Issue #1: Optional PSE behavior exists in the text; is not yet represented in SD.

CI 33	SC 33.2.6	P 90	L 6	# 123
Stover, David		Linear Technology		
Comment Type	T	Comment Status	A	PSE Detection
Allowable detection behavior is inconsistent between CC_DET_SEQ variants. Particularly, CC_DET_SEQ 3 is unique in that an invalid detection signature on alt_pri prevents PSE from investigating alt_sec.				
<i>SuggestedRemedy</i>				
Add the following text: "A Type 3 or Type 4 PSE detecting an invalid PD signature on either alternative may perform detection on the other alternative."				
Response		Response Status	C	
ACCEPT IN PRINCIPLE.				
Add the following text: "A Type 3 or Type 4 PSE detecting an invalid PD signature on either alternative may perform detection on the other alternative, and if valid may perform classification on that pairset."

Figure 33-17—Type 3 and Type 4 Secondary Alternative dual-signature semi-independent PSE state diagram

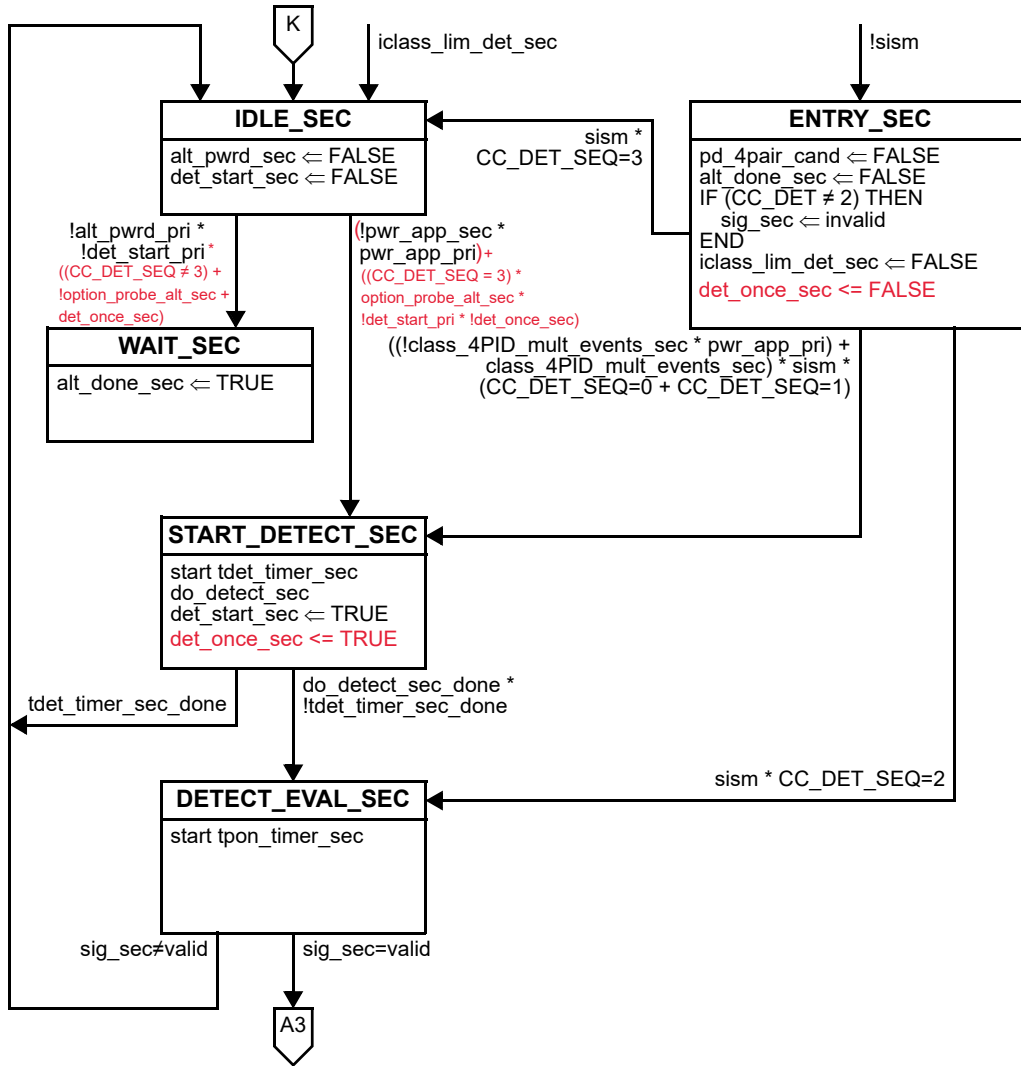
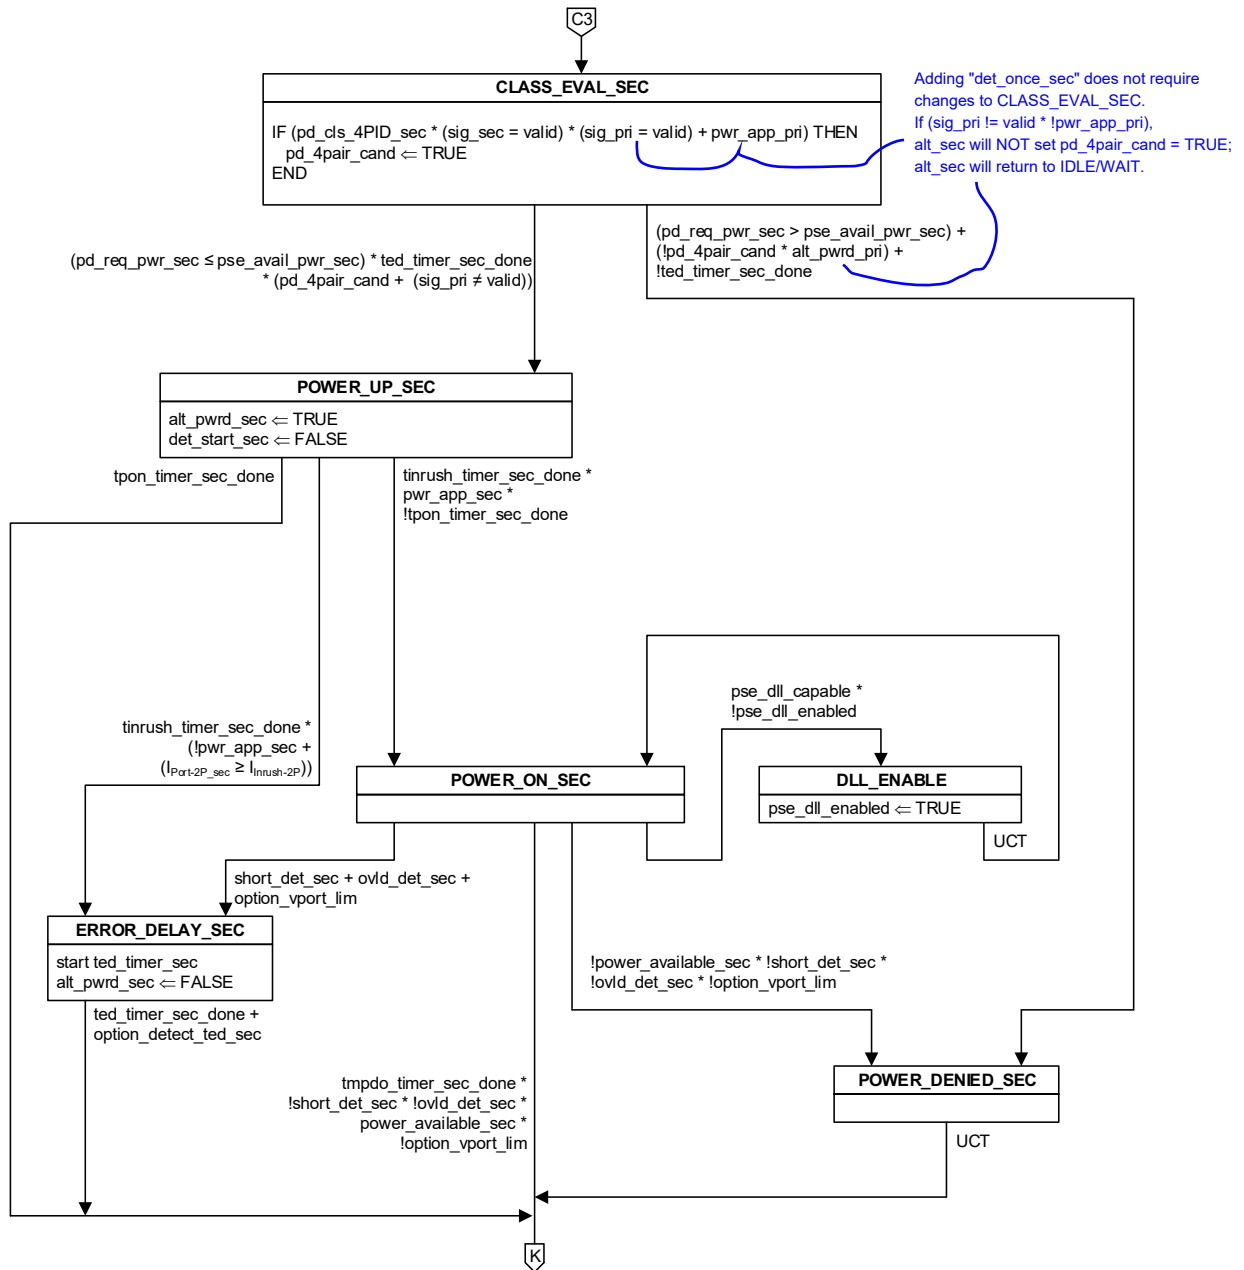
2. Make the following modifications to PSE state diagram (see next page)

Proposed fix:

1. Add the following to the PSE variables section

#### option\_probe\_alt\_sec

This option variable indicates if the PSE will continue to detect and conditionally class on the Secondary Alternative in the event an invalid detect or class result is found on the Primary Alternative. This variable applies to CC\_DET\_SEQ = 3.

#### det\_once\_sec

This variable indicates if the PSE has probed the Secondary Alternative at least once following exit from ENTRY\_SEC. This variable is only valid when sism is TRUE.

Figure 33–18—Type 3 and Type 4 PSE single-signature classification state diagram

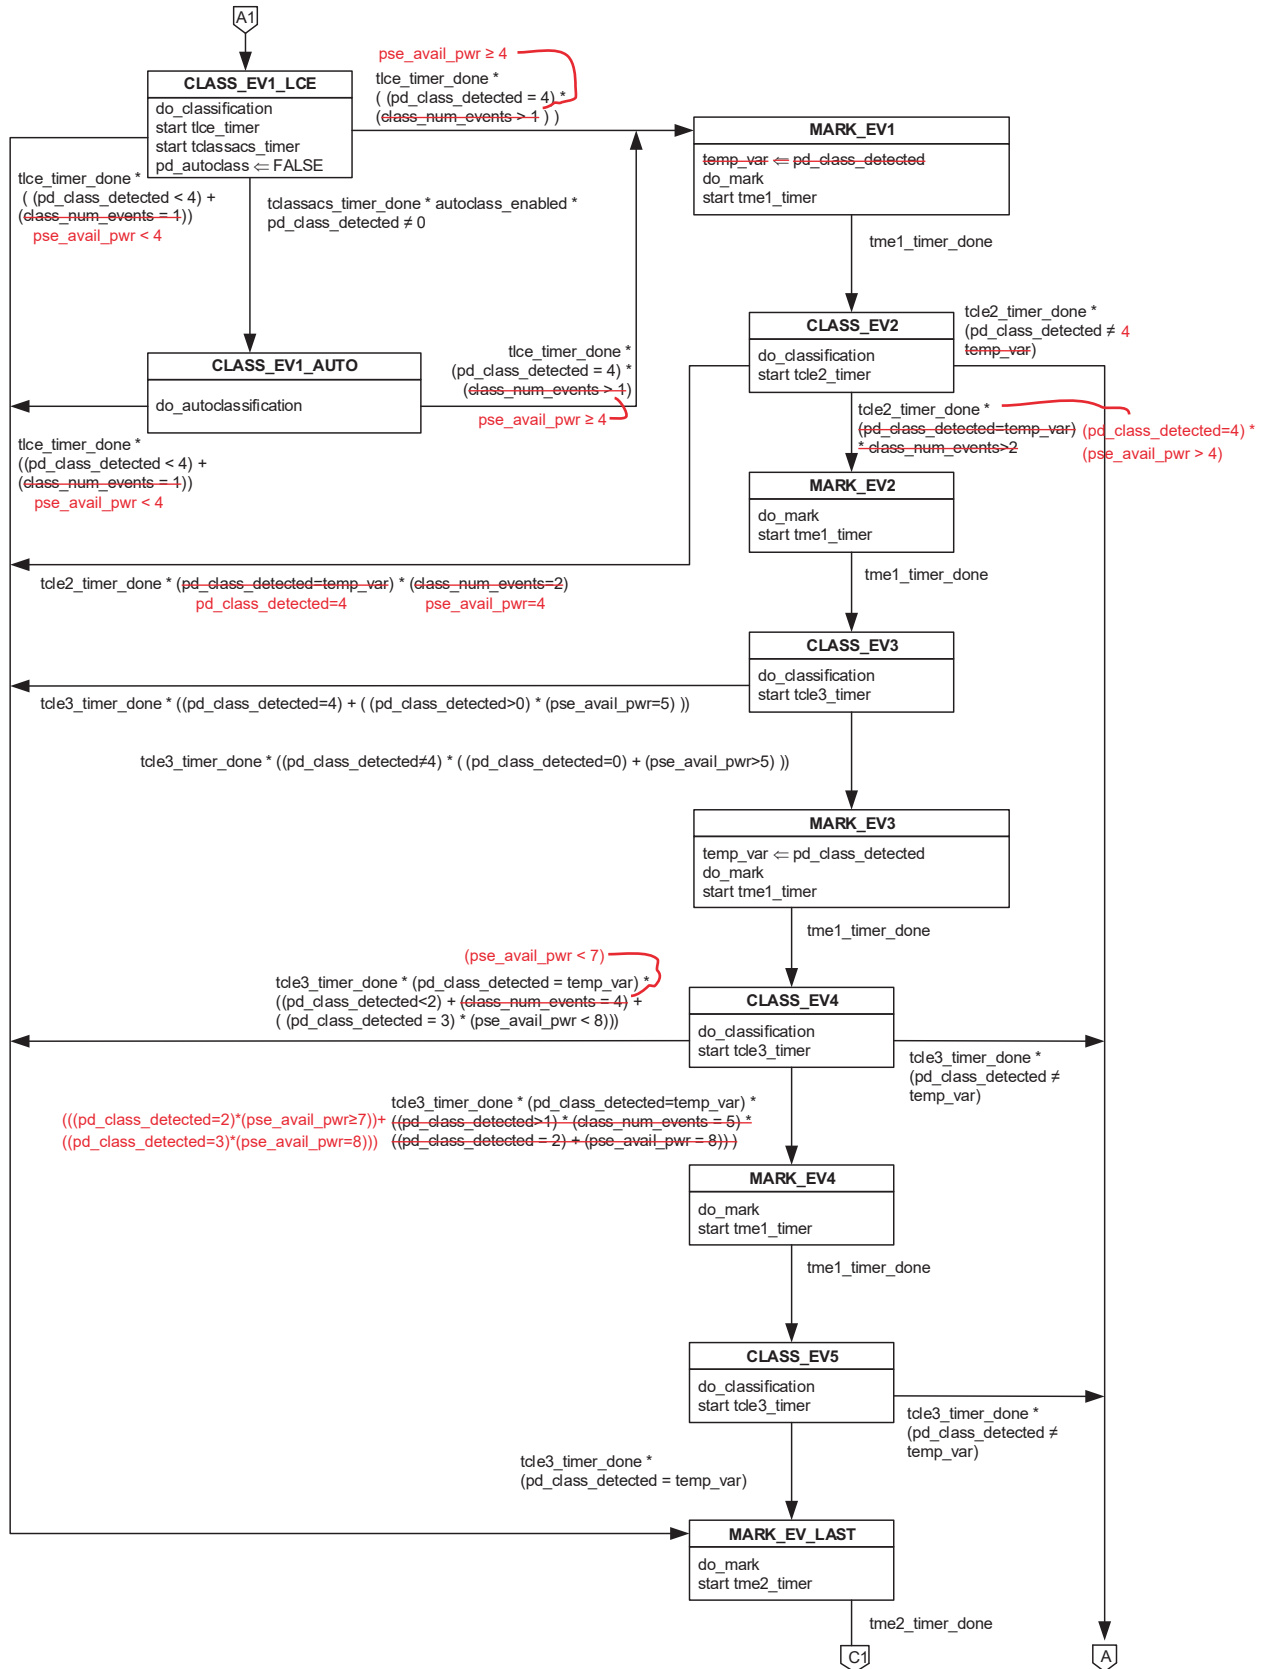
Issue #2: Classification in PSE SD is expressed in terms of `pse_avail_pwr`, `class_num_events`. Behavior in PSE SD today may not perform as intended.

Proposed fix: Make the following changes to PSE SD (see next page)

Figure 33–19—Type 3 and Type 4 PSE dual-signature classification state diagram on the Primary Alternative

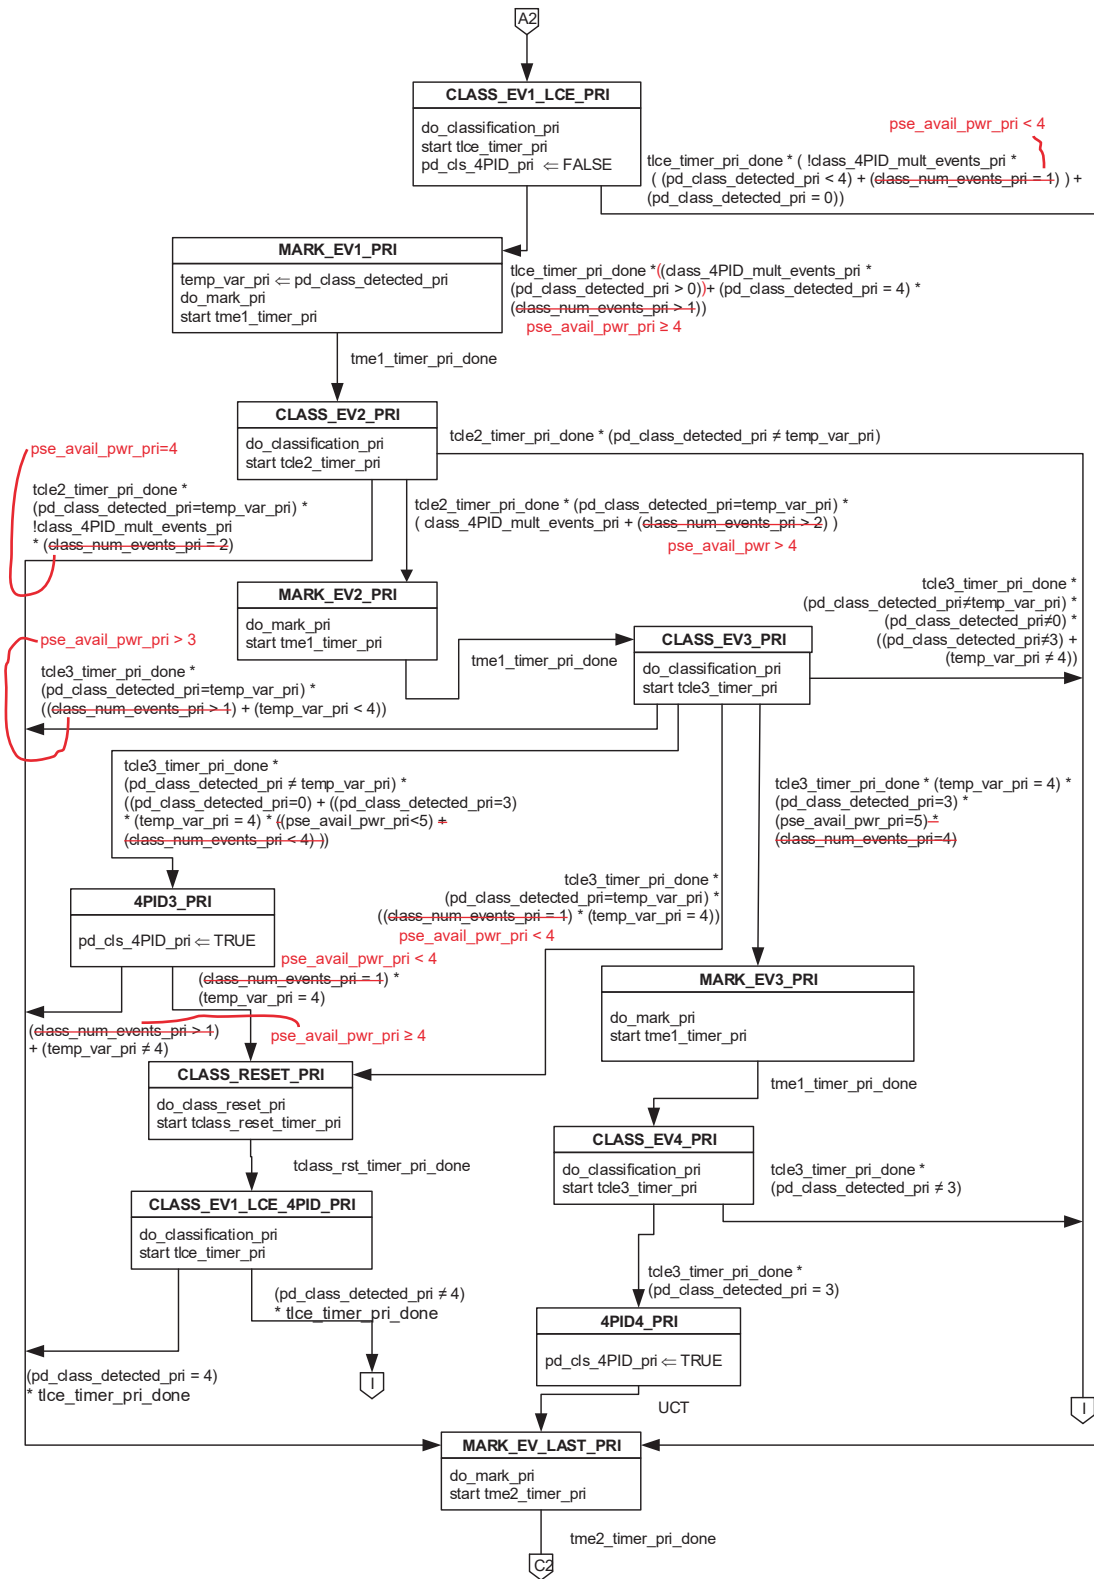
NOTE: Repeat these changes for "\_SEC" Class SD
